date:	5.17.24
project:	Hyde Park Middle School
by:	Michael Rigby
subject:	Addendum 03

CONTRACT ADDENDUM 03

M-111.F

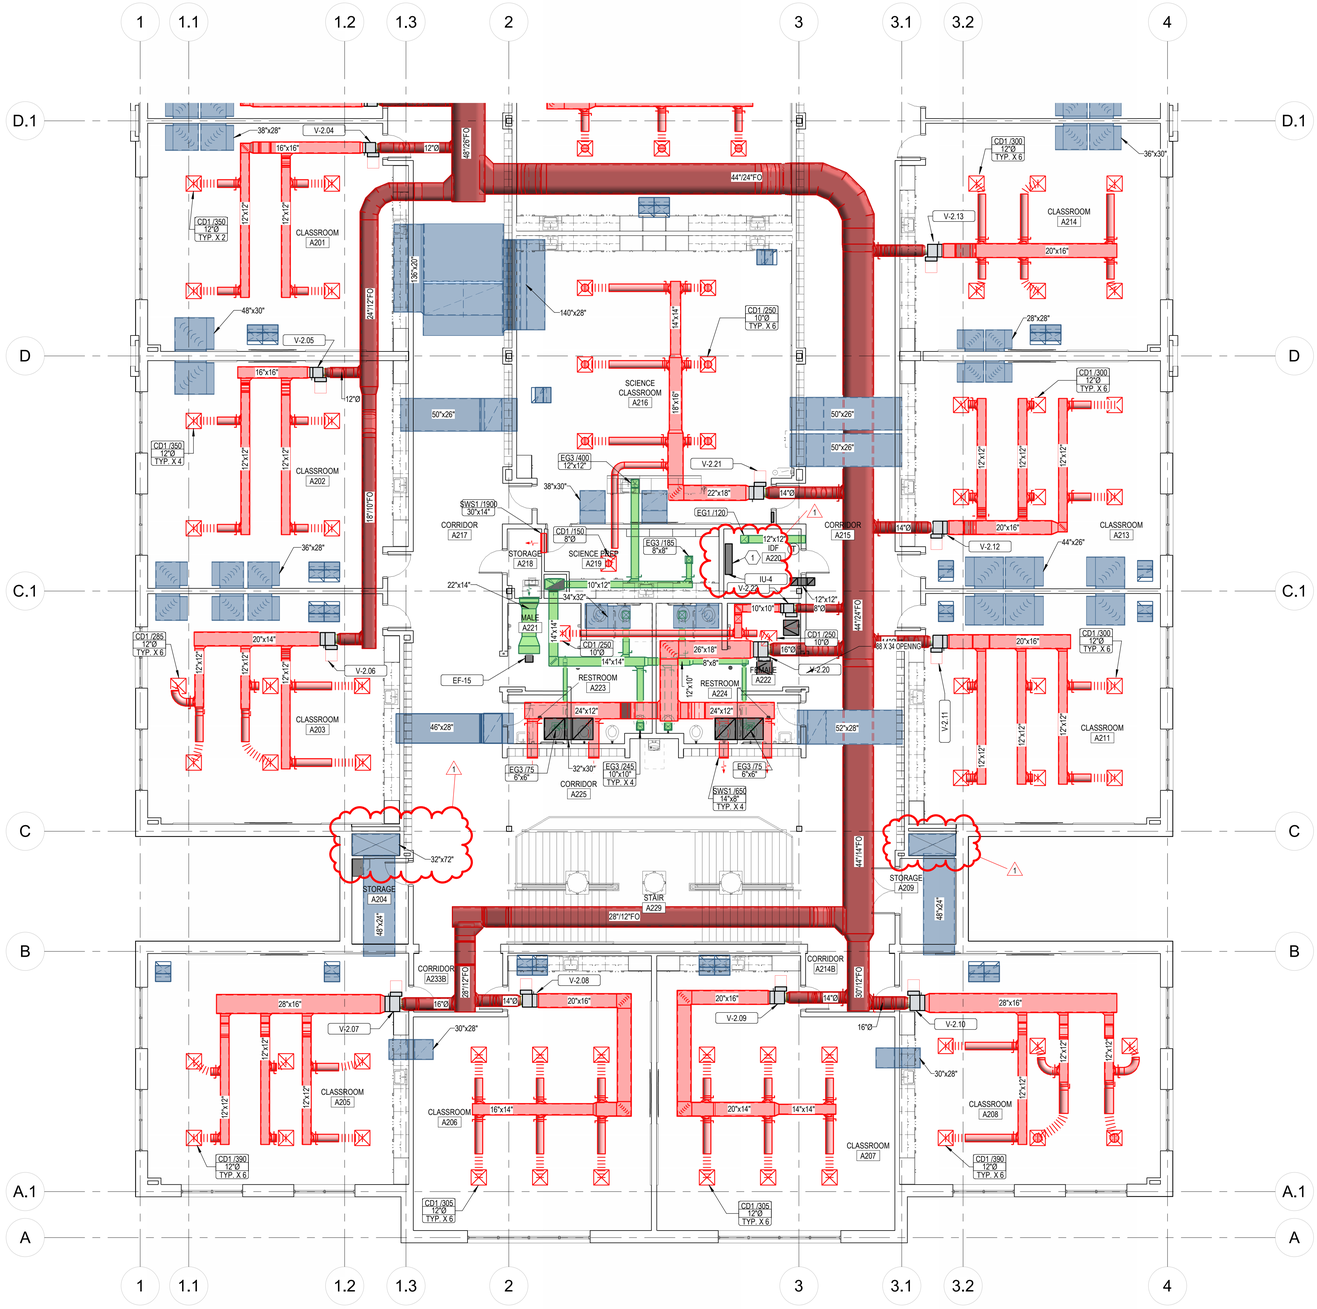
SHEET - M111.F
1. Add keyed note 1 as shown. See attached.

M-112.A

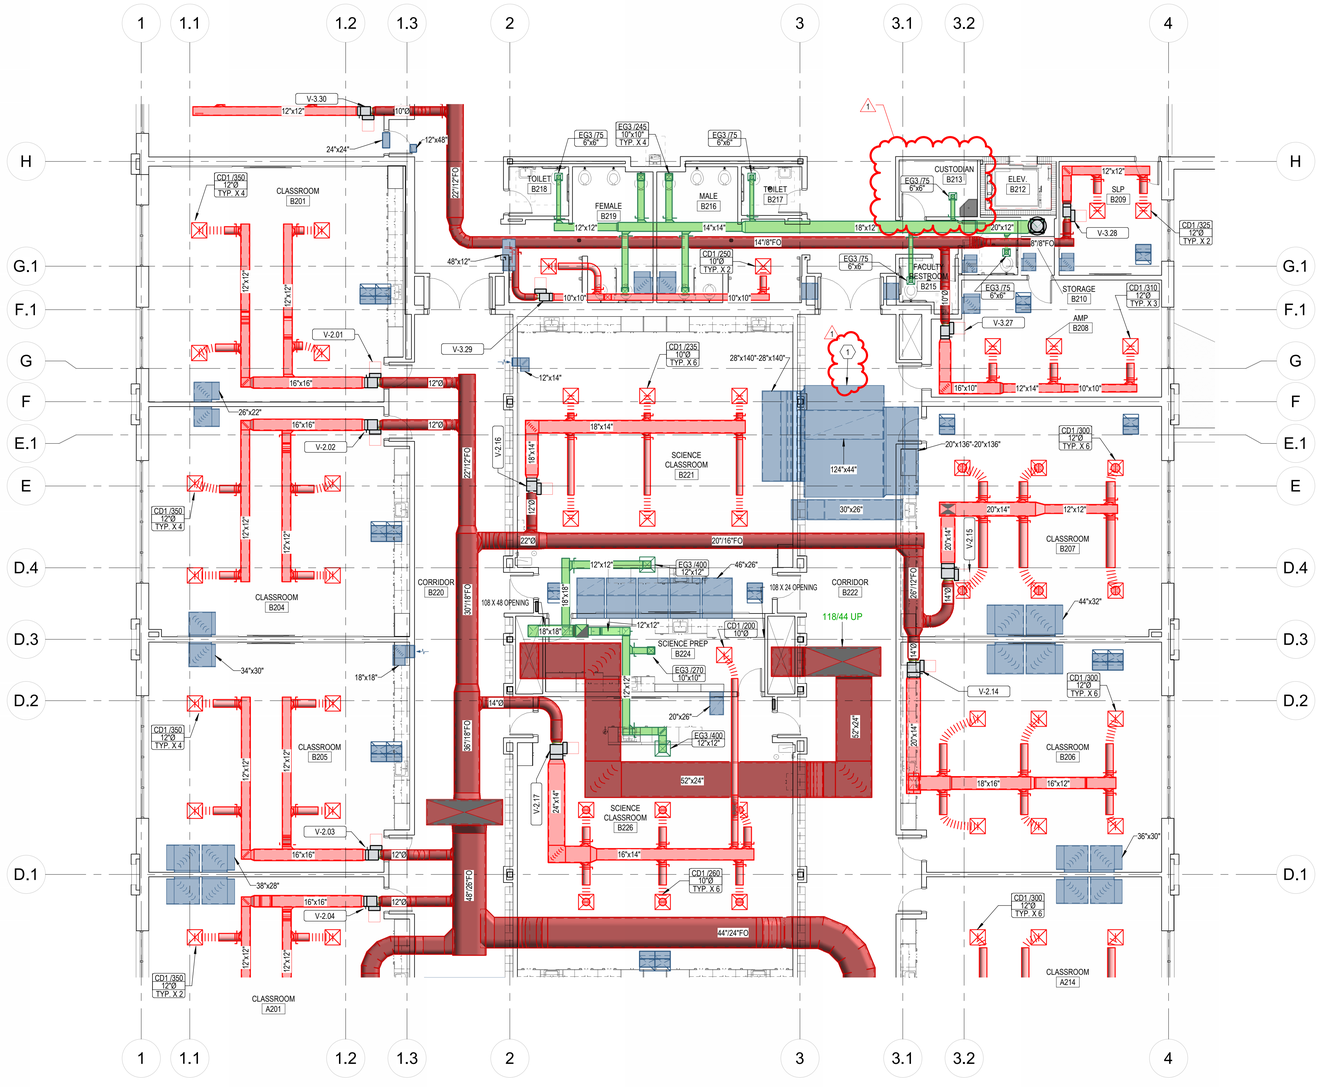
SHEET - M112.A
1. Add keyed note 1 as shown. See attached.
2. Modify duct riser in shaft as shown. See attached.

M-112.C

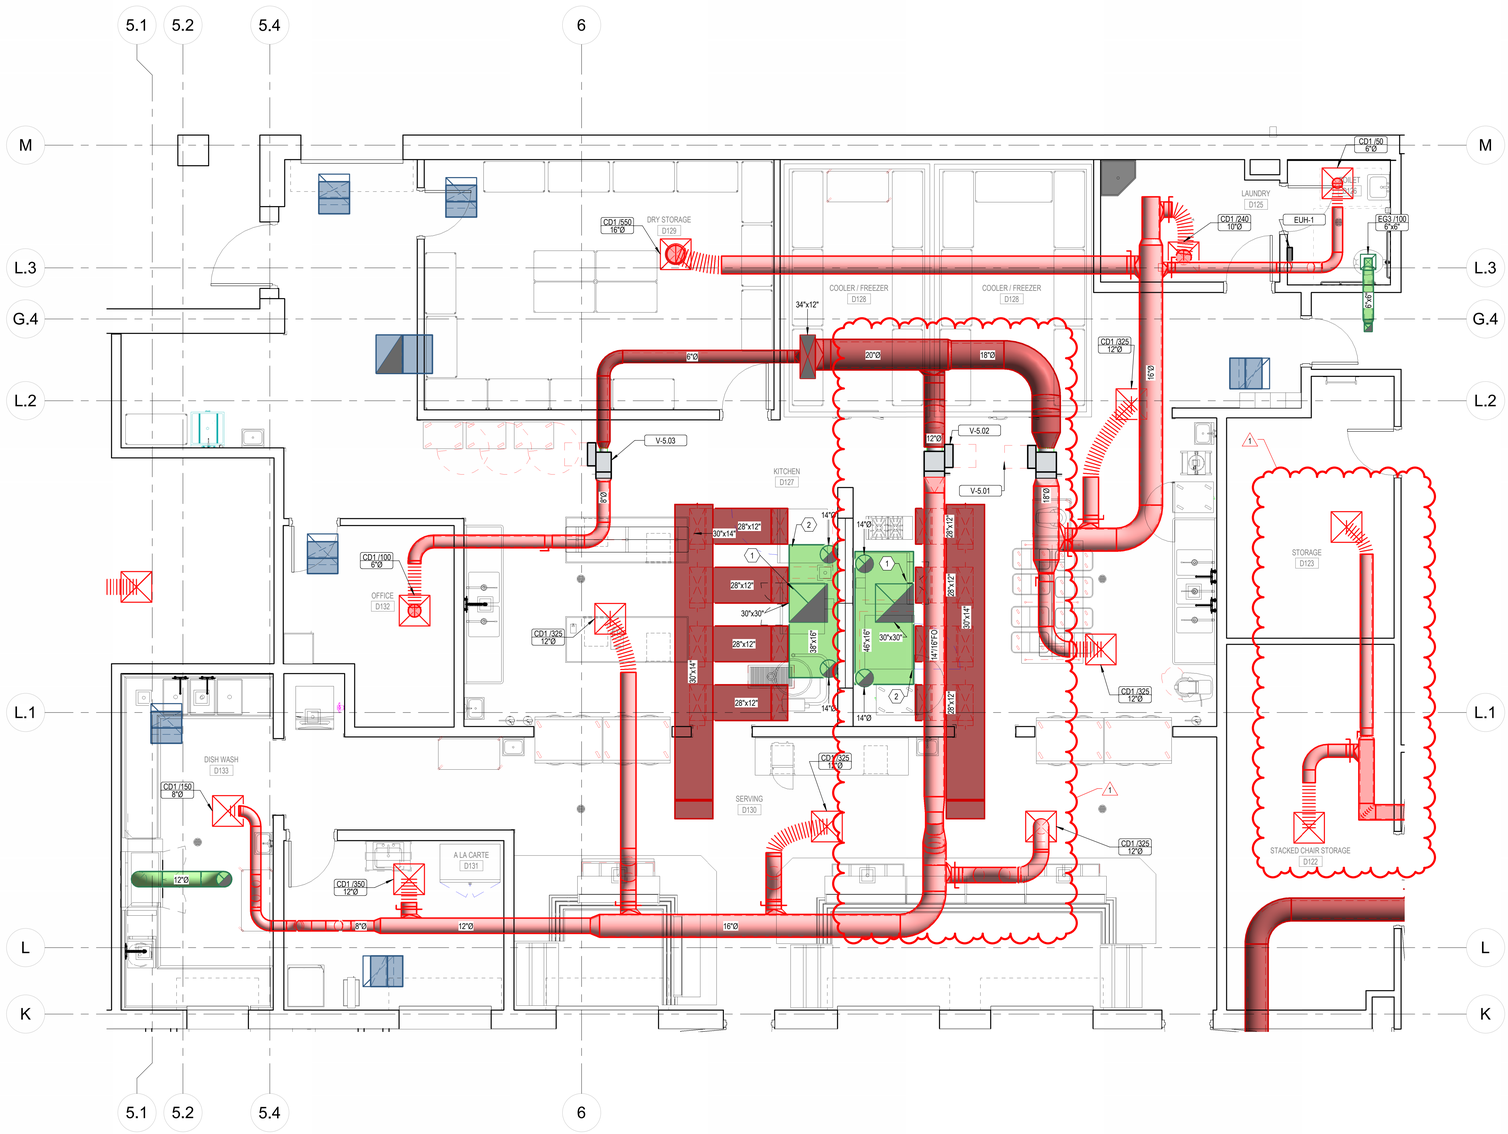
SHEET - M112.C
1. Add keyed note 2 as shown. See attached.

1 / M-403 ENLARGED MECHANICAL HVAC PLAN - CHILLER ROOM
1/4" = 1'-0"

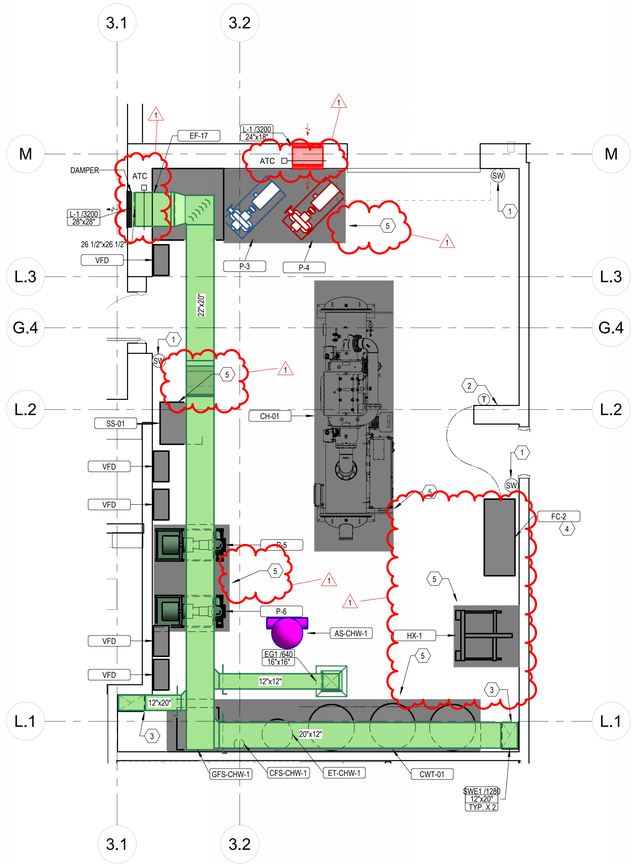
SHEET - M403
1. Add motorized dampers as shown. See attached.
2. Add keyed notes to pads as shown. See attached.

2 M-505 KITCHEN MAKE-UP AIR HANDLER DETAIL
NO SCALE

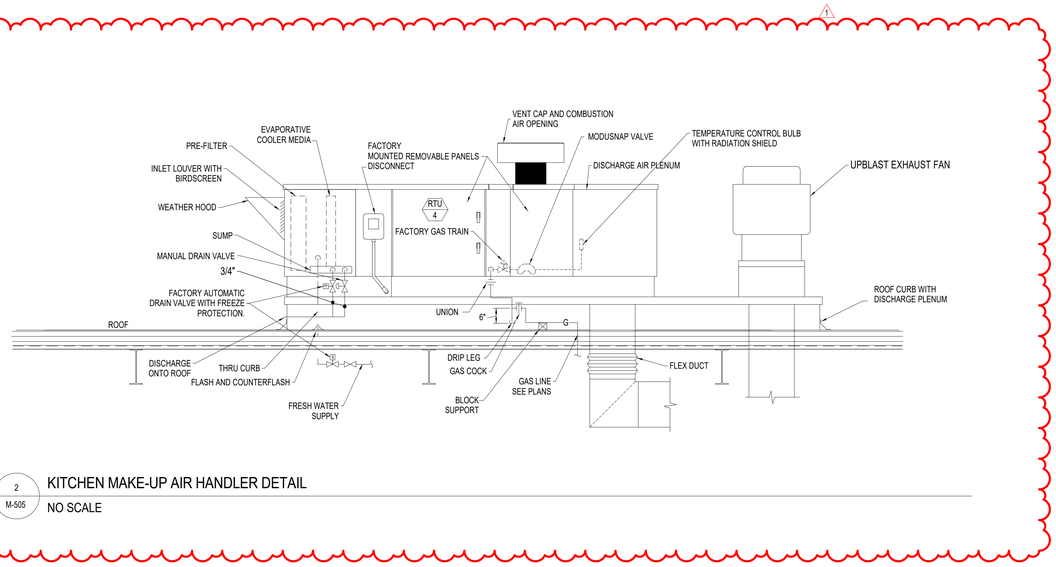
SHEET - M505
1. Add Make-Up Air Handler Detail as shown. See attached.

MP-111.C

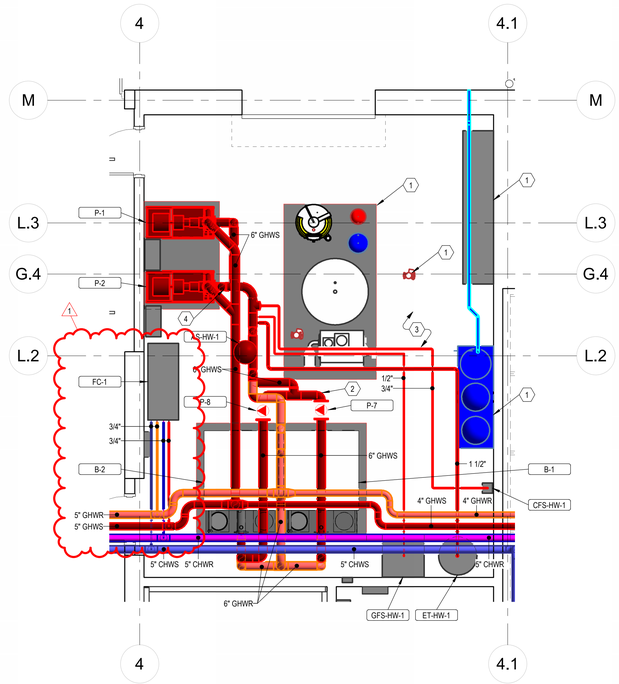
SHEET - MP111.C
1. Add hydronic piping as shown. See attached.

MP-402

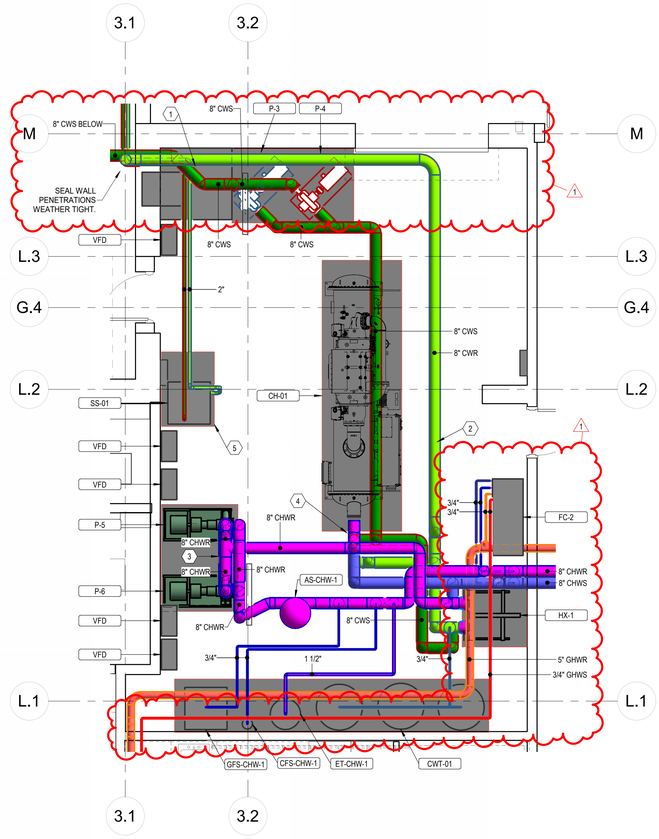
SHEET - MP402
1. Tag FC-1.

1 MP-401 ENLARGED MECHANICAL PIPING PLAN - COOLING TOWER
1/4" = 1'-0"

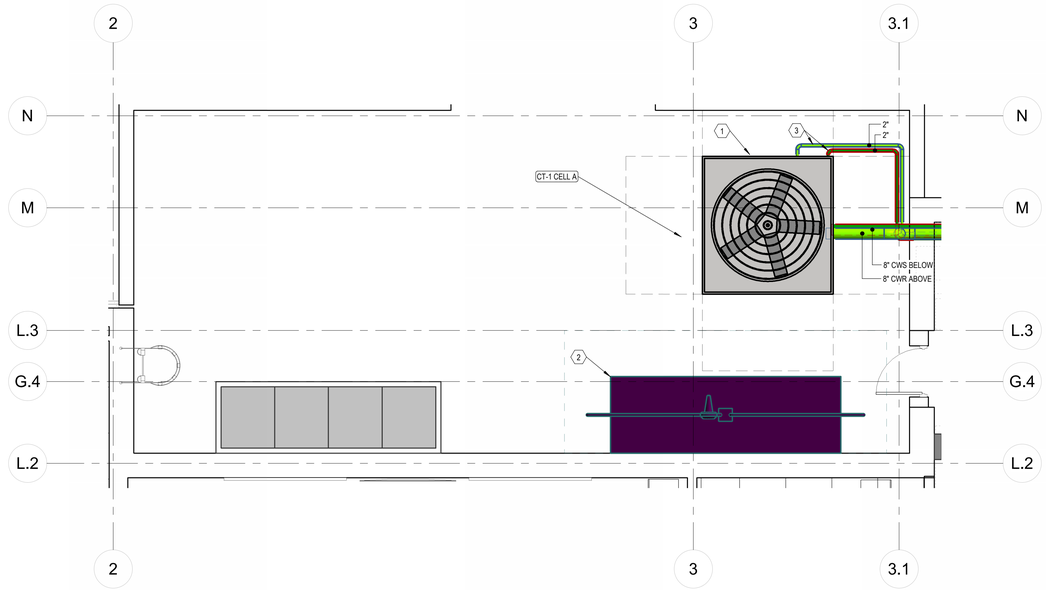
SHEET - MP401
1. Remove extra keyed notes as shown. See attached.

MP-702

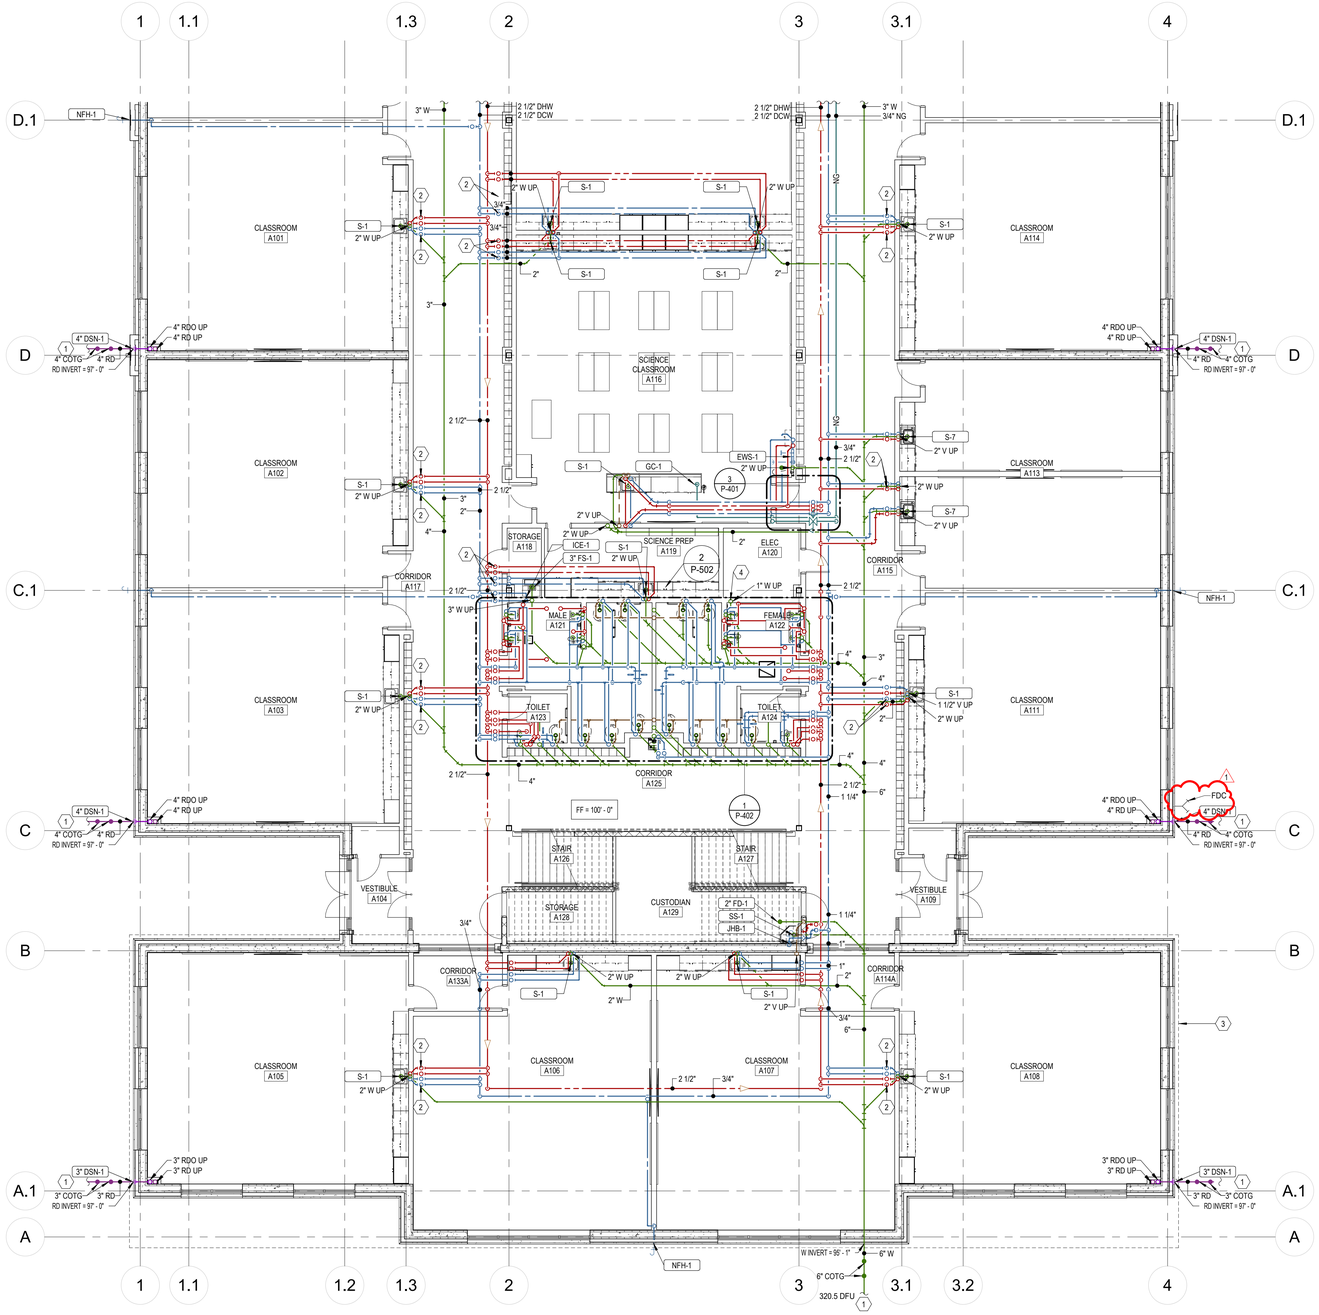
SHEET - MP702
1. Modify piping as shown. See attached.

P-111.A

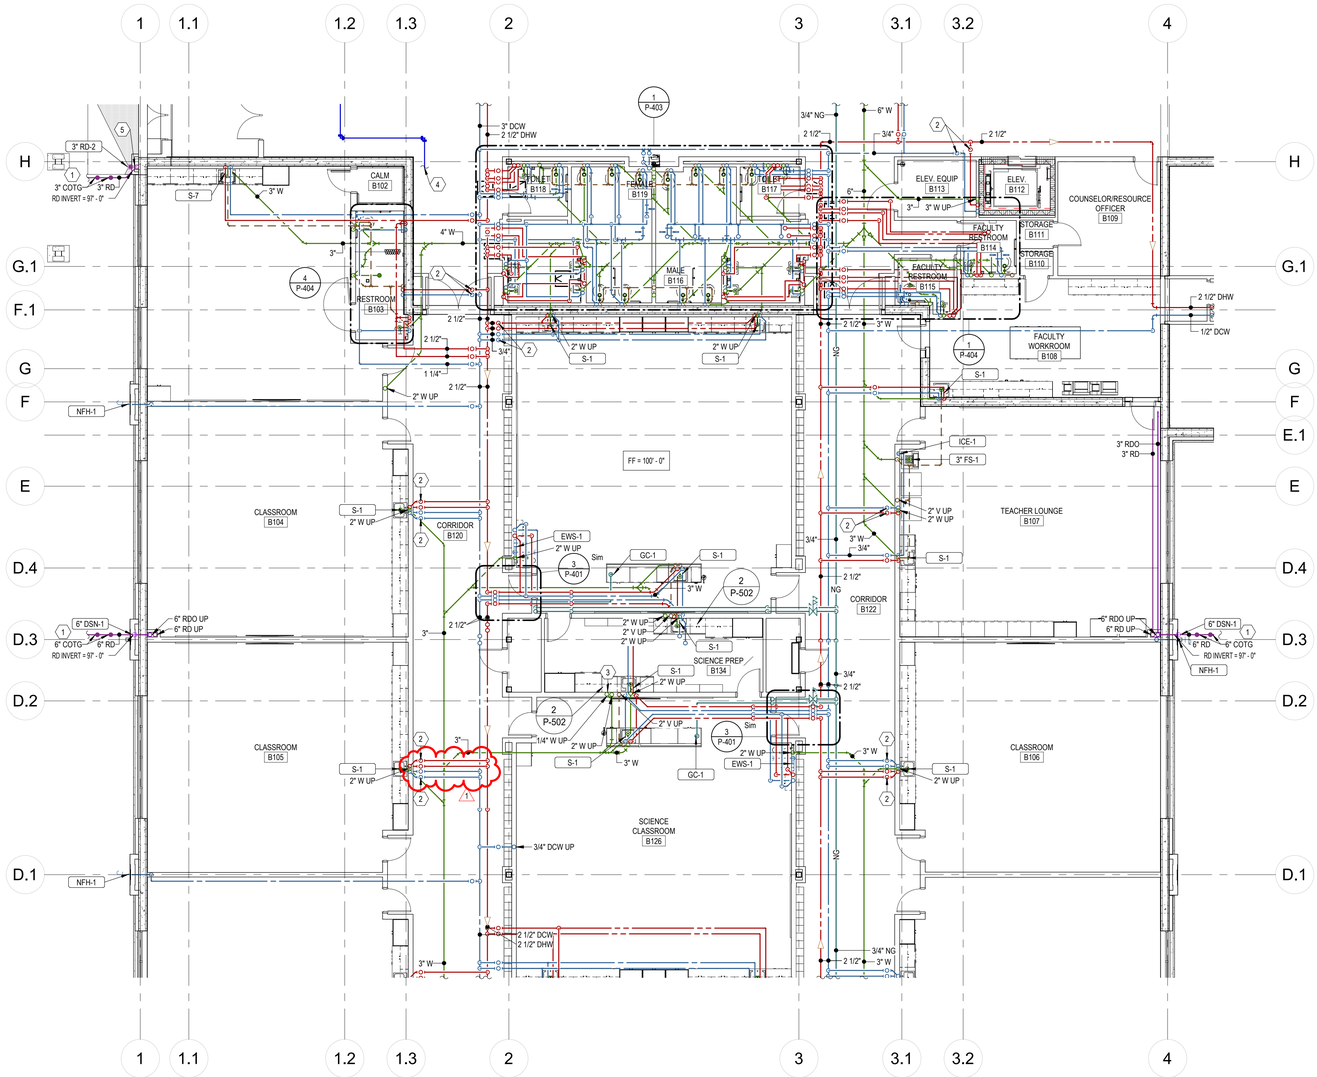
SHEET - P111.A
1. Locate the FDC as shown. See attached.

1 P-401 BOILER ROOM PLUMBING PLAN
1/4" = 1'-0"

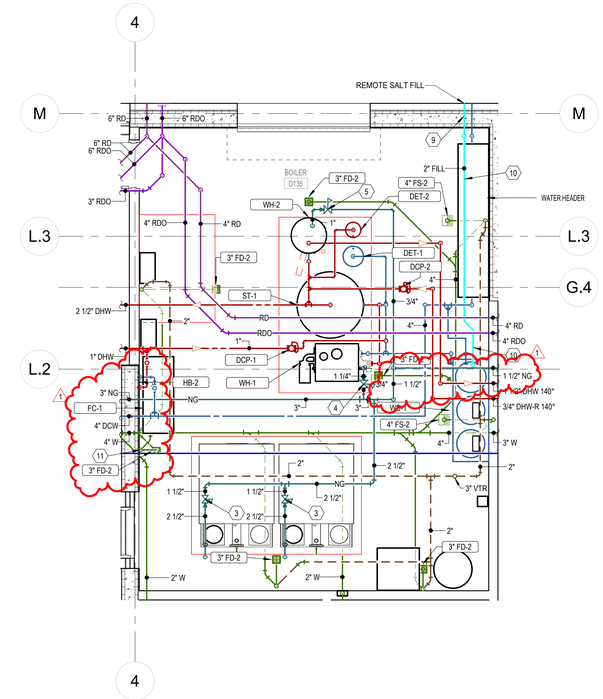
SHEET - P401
1. Modify gas piping as shown. See attached.
2. Add condensate drain to fan coil unit as shown. See attached.
